REGULAR MEETING OF THE UNITED LAGUNA WOODS MUTUAL ARCHITECTURAL CONTROL AND STANDARDS COMMITTEE

Thursday, March 21, 2019 – 9:30 a.m. Laguna Woods Village Community Center Elm Room 24351 El Toro Road

SUBJECT: Variance Request: Mr. Roger Flinn of 126-D (Majorca, 8A)

SUBJECT: Variance Request: Mr. Gary W Caracciolo of 836-O (Cadiz, 6A)

126-D AVENIDA MAJORCA LAGUNA WOODS, CA 92637

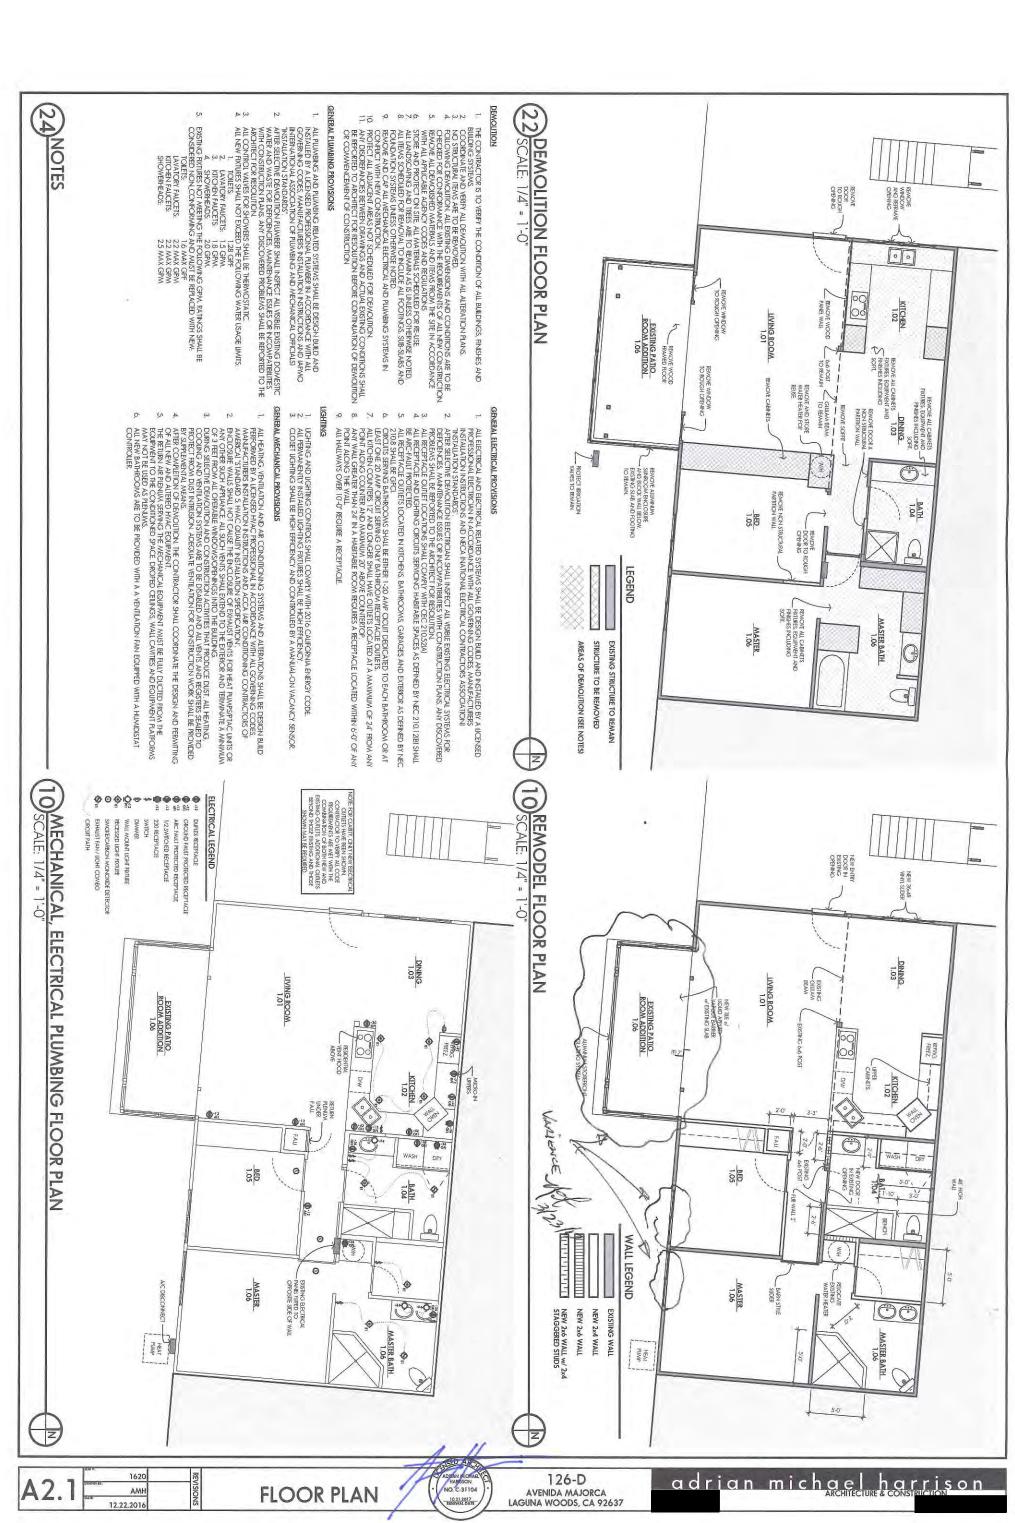
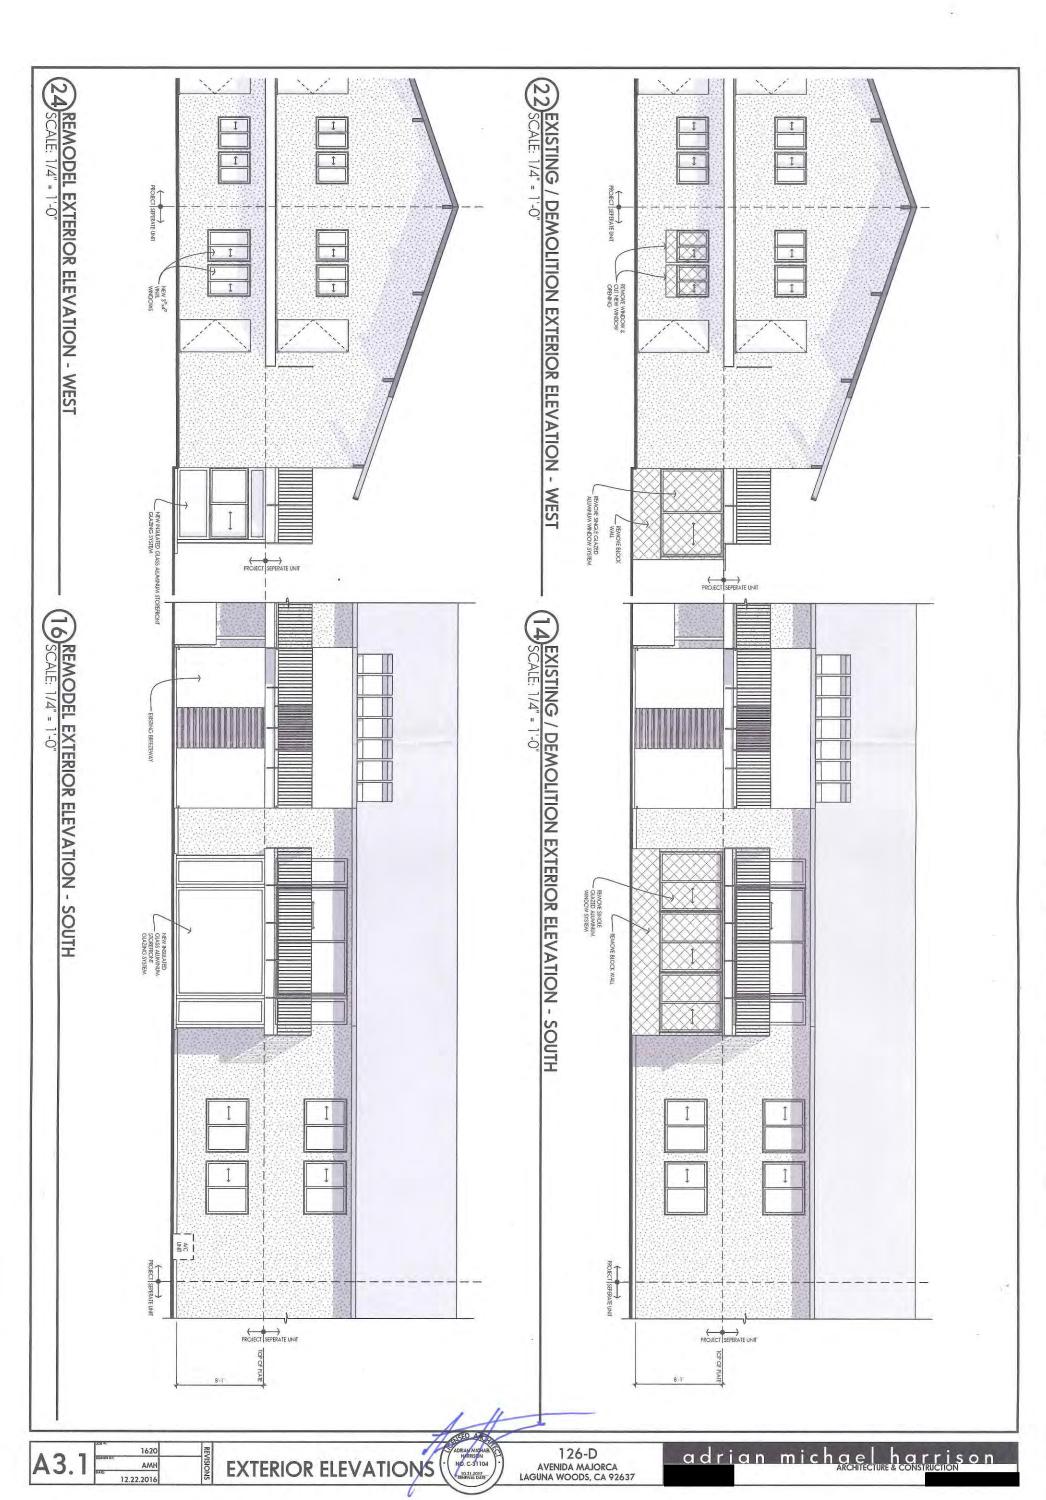
The plans submitted and approved for the original variance in June 2017, show plan and elevation drawings depicting only windows to be used to construct a 16'11" by 8' patio enclosure within the existing front patio of the unit (Appendix B). Due to the proposed glazing system containing only windows, Common Area was not required for the patio enclosure. Furthermore, staff made contact with the projects' architect prior to the Committee's review and confirmed that emergency egress requirements would be satisfied with both the proposed window system and the existing living room entry door.

During a recent inspection, staff found windows were replaced with a single swing door, 2'8" wide by 6'11" tall on both east and west elevations of the alteration. For the alteration to meet local and state building codes, the new doors to the patio enclosure would require a concrete landing that would fall onto Common Area.

Based upon the existing United Mutual Common Area Usage Policy, and with the ability to meet egress requirements using windows that do not require a landing on Common Area, staff recommends denial of doors on the alteration patio enclosure.

Staff recommends the Board deny the appeal to retain doors on the room extension. Should the Board approve the appeal, staff recommends approval be with the conditions as stated in Appendix A.

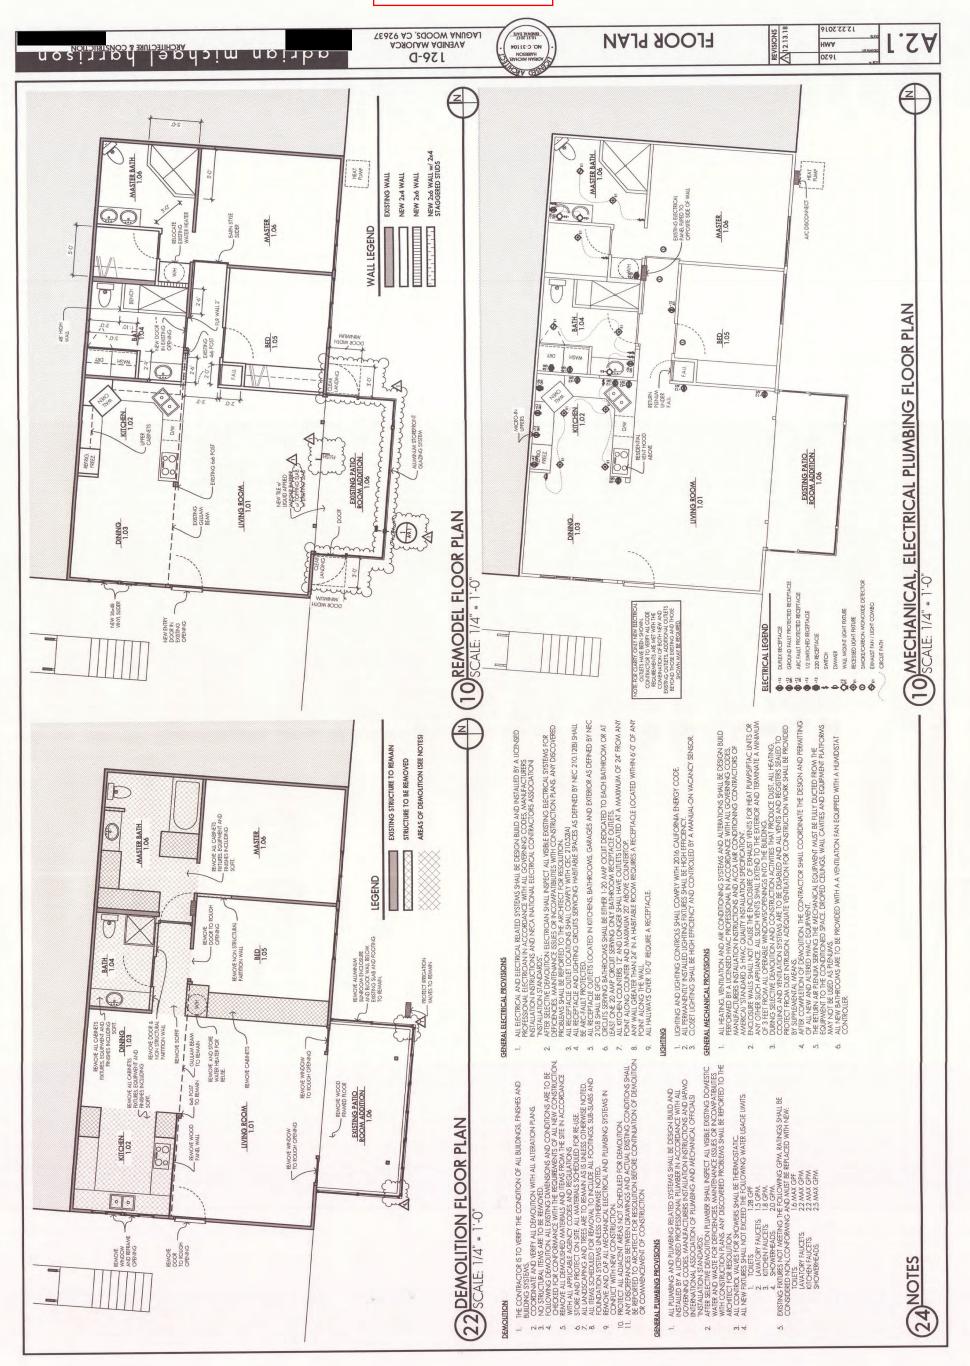
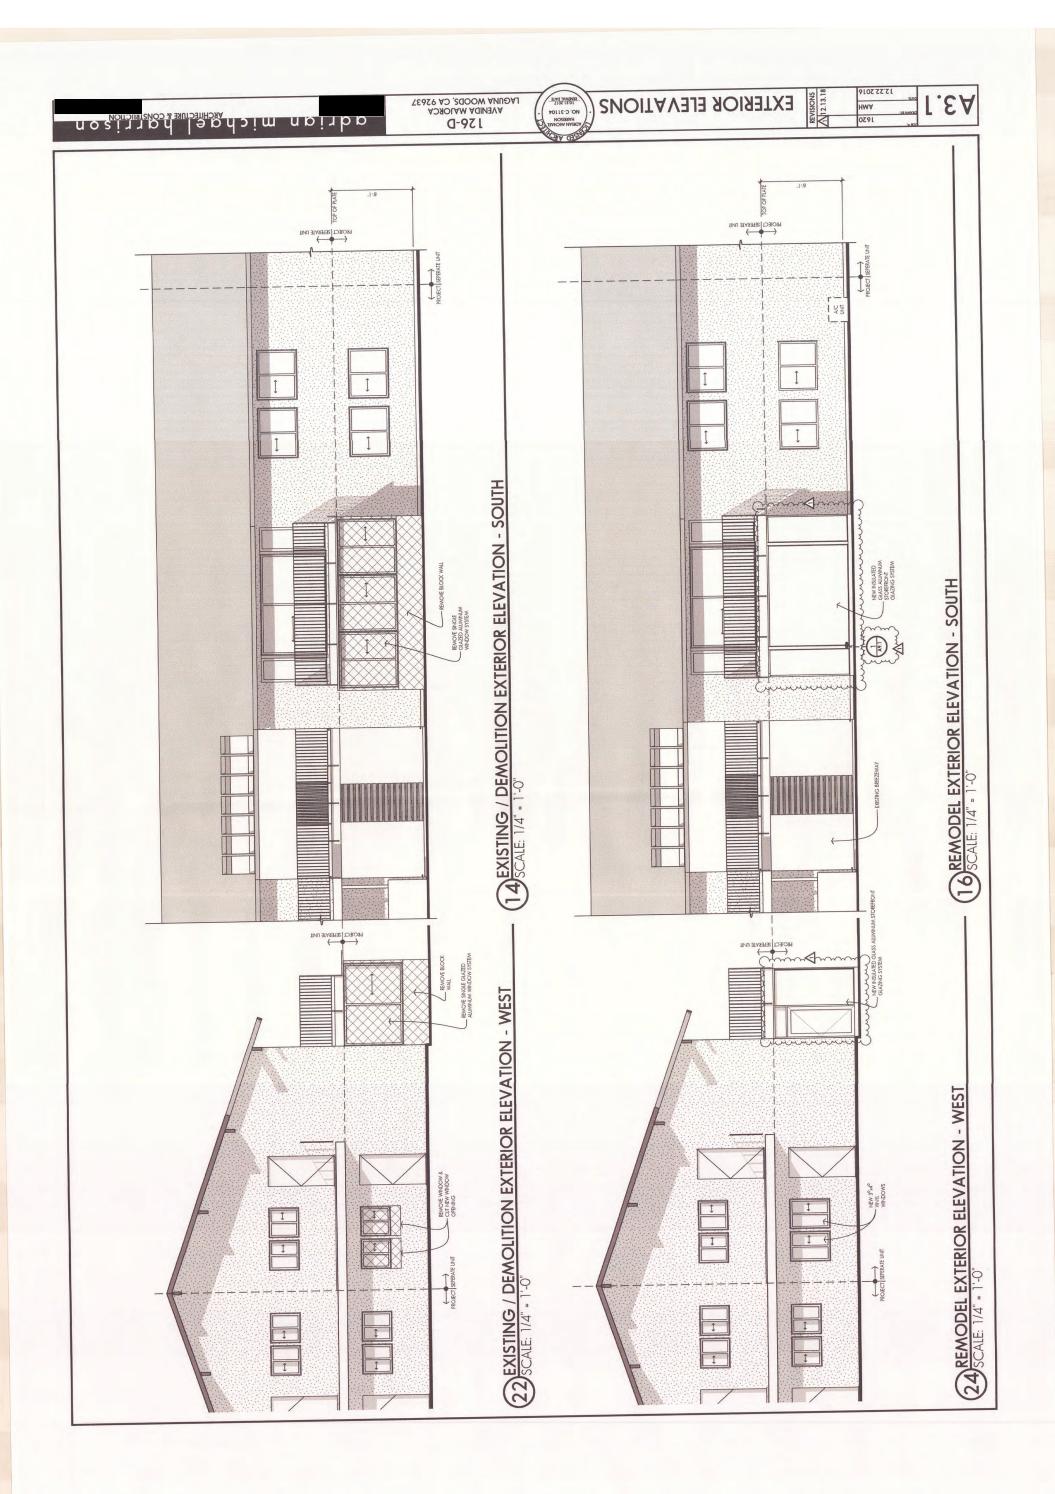
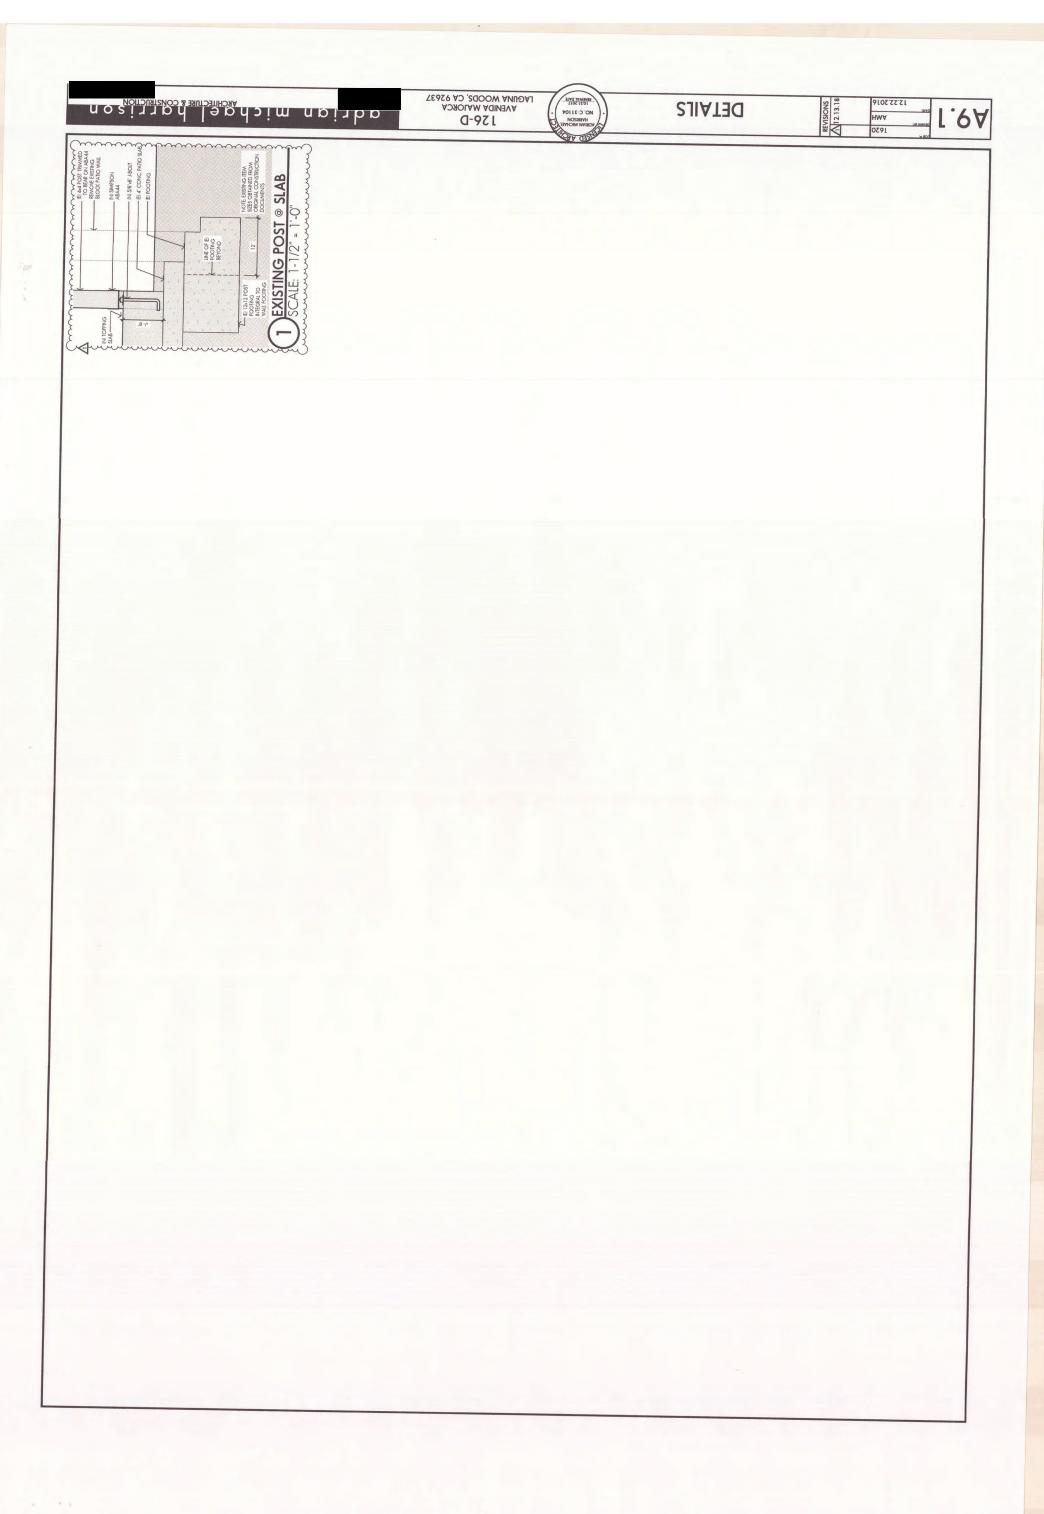
I was able to get out to the unit today, unfortunately there are some issues with the existing work that need to be corrected. A Stop Work/Correction Notice was issued (see attachment).

The doors on either side of the enclosure have to be removed. Exterior doors require a concrete landing which would fall on Common Area; United Mutual have an existing Policy that prohibits any Member from repurposing the common area for their own use.

Additionally, there is no existing approval for the removal of the sliding glass door. Board approval would be required to change this alteration from a Patio Enclosure to a Room Addition, as well as passing City Inspection to show the addition meets Title 24 requirements.

The Variance approval was for the glazing and did not mention any removal of the doors.

At this time either corrections can be made to bring the unit into compliance within 30 days or a variance to retain the existing alteration can be made.
